RESPONSES TO  
NRC QUESTION  
ON THE  
DUANE ARNOLD ENERGY CENTER  
PUAR

PREPARED BY  
NUTECH ENGINEERS, INC.  
SAN JOSE, CALIFORNIA

PREPARED FOR  
IOWA ELECTRIC LIGHT AND POWER CO.

NRC QUESTION ON DUANE ARNOLD ENERGY CENTER

Figure 14 - 6"φ

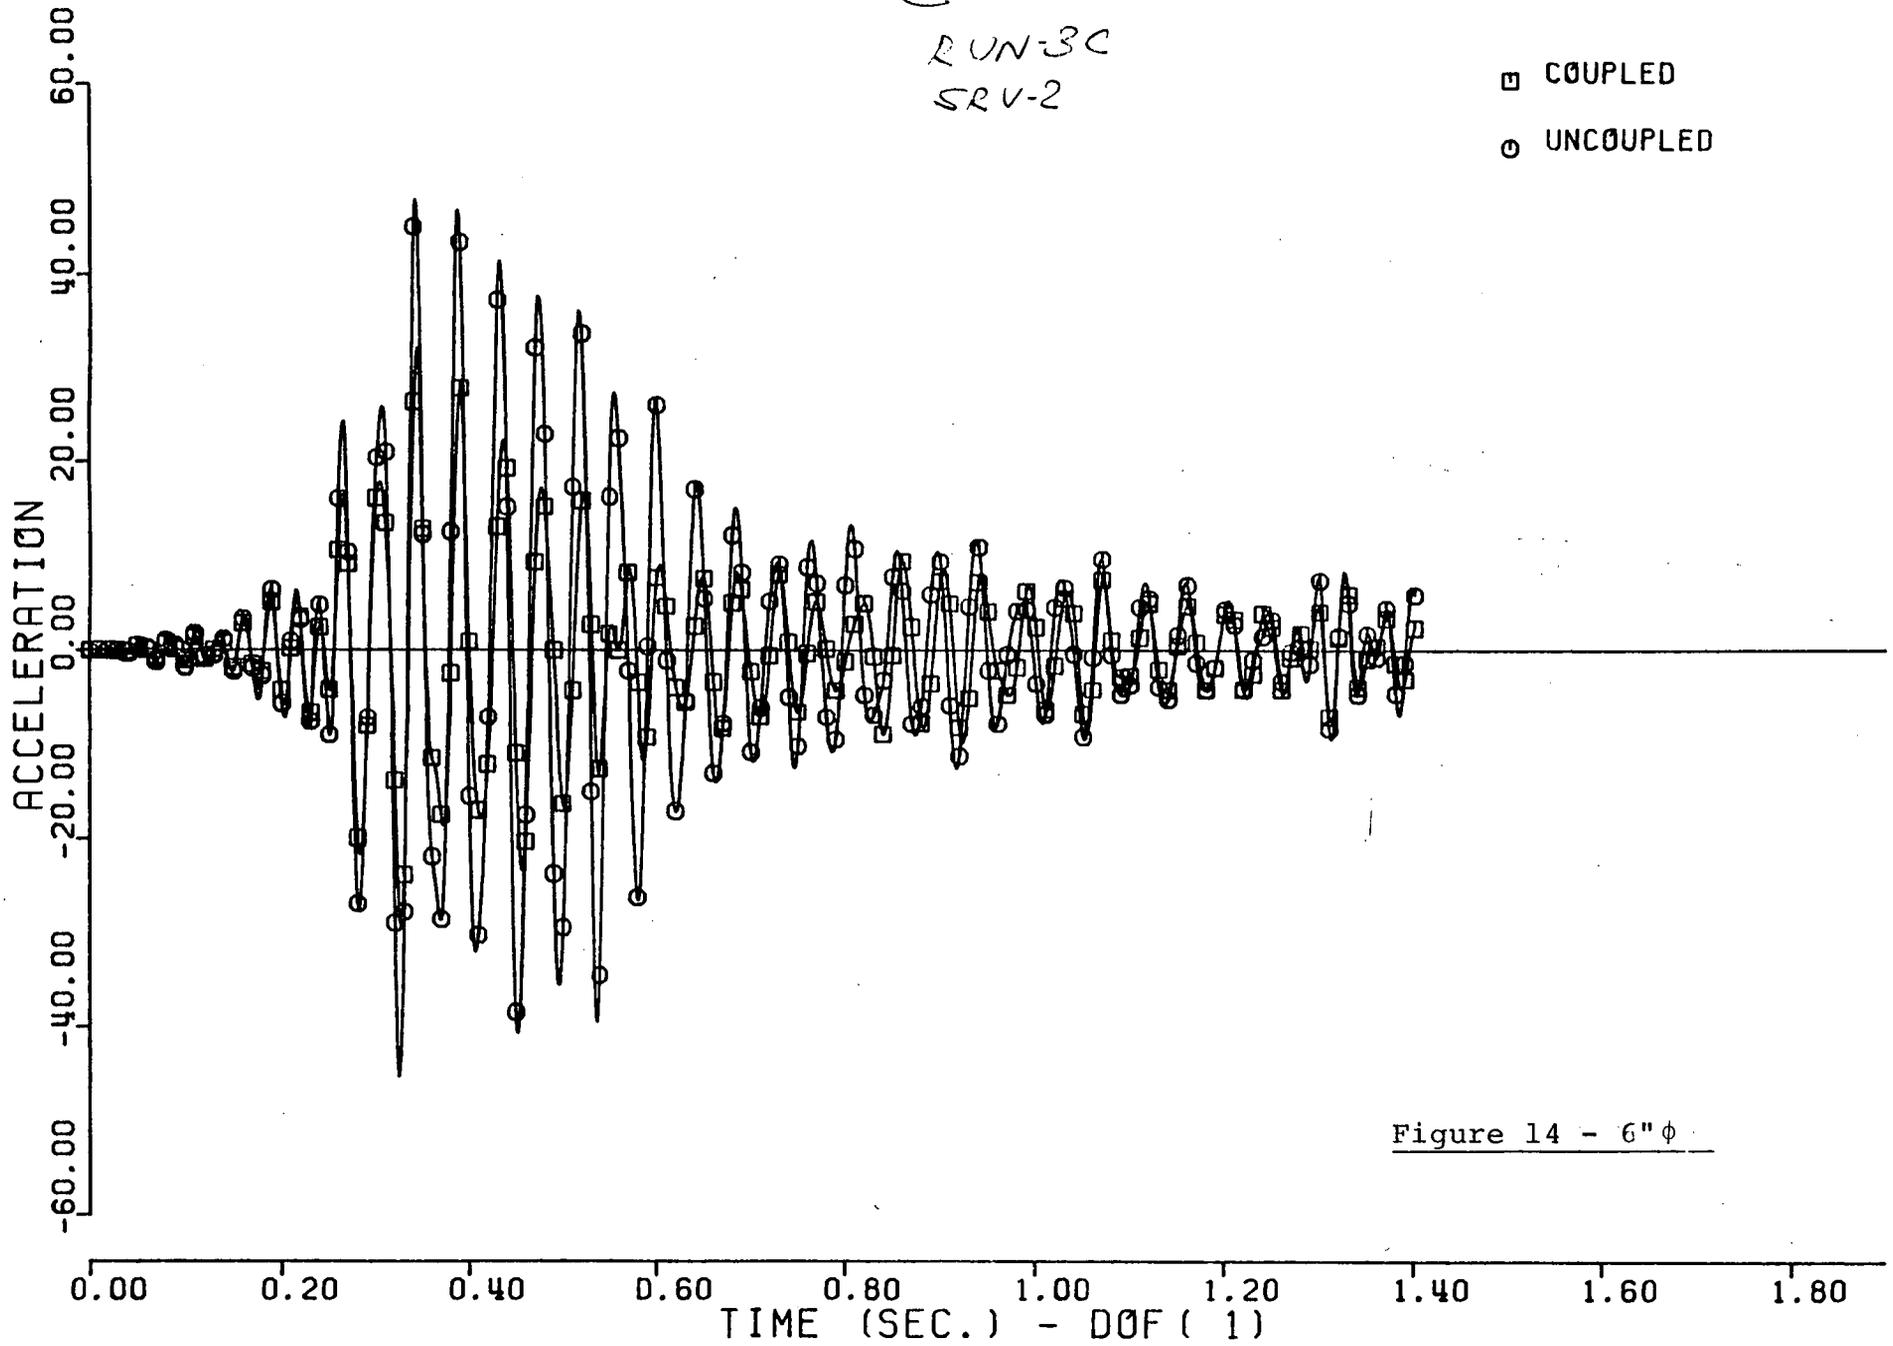
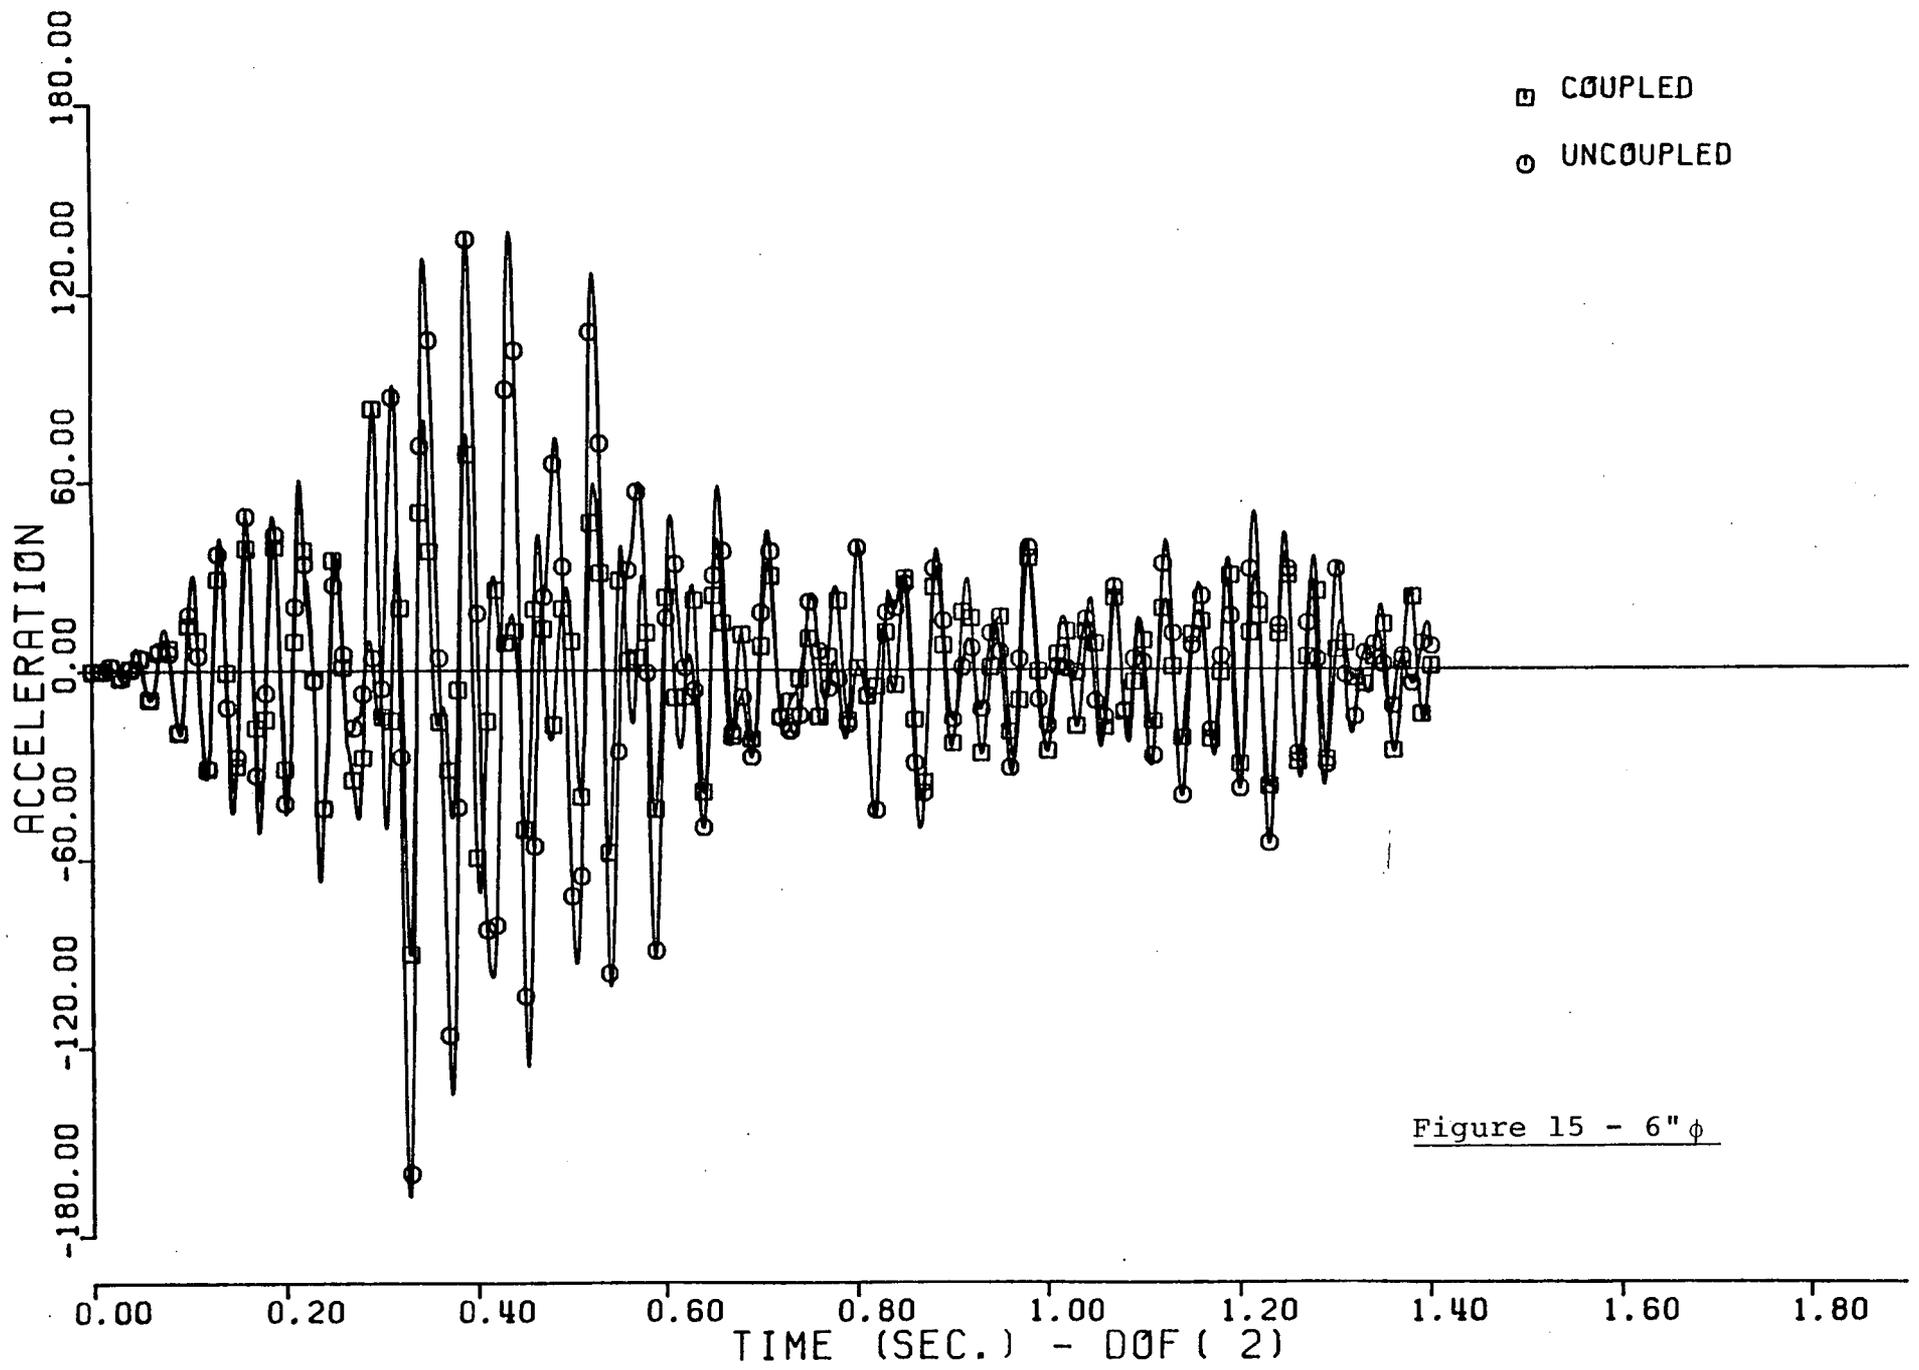
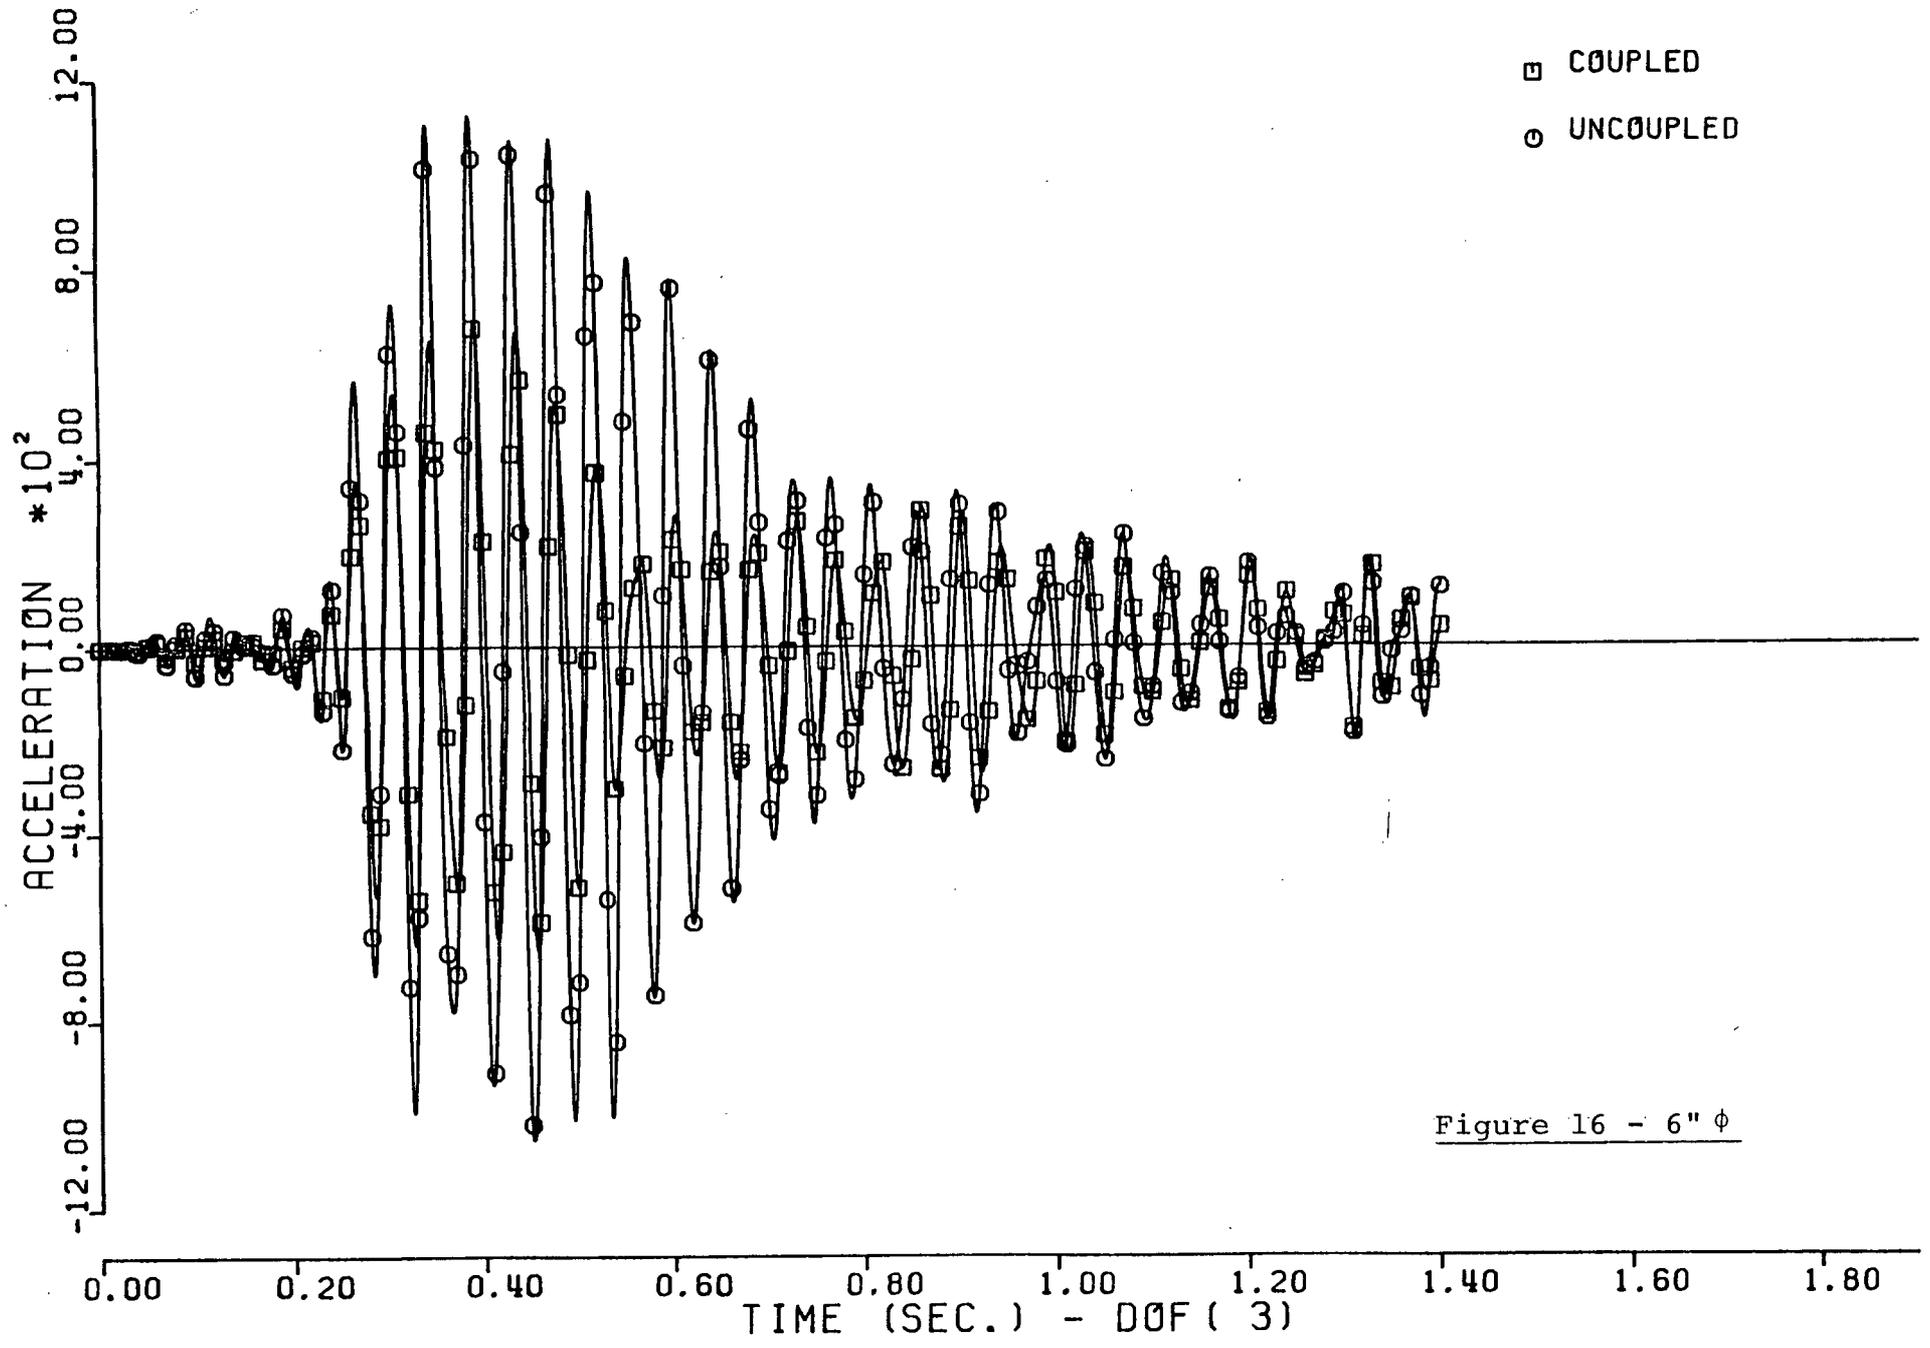
ITEM 3a: Provide the theoretical background in support of Section 2 of the report, and describe how the Section 6 guidelines (i.e., cut-off frequency and equations 2.27 and 2.28) have been used in the analysis.

To illustrate the effect of pipe size on coupling, four typical piping systems were examined and the coupled and uncoupled time histories plotted together. These time histories include both the smallest (2") and larger (20") systems analyzed. Listed below are the figure numbers and the corresponding line size.

Figure 4-8	2" diameter
9-13	4" diameter
14-18	6" diameter
19-21	20" diameter

These plots confirm the expected variation of coupling benefit with pipe size.
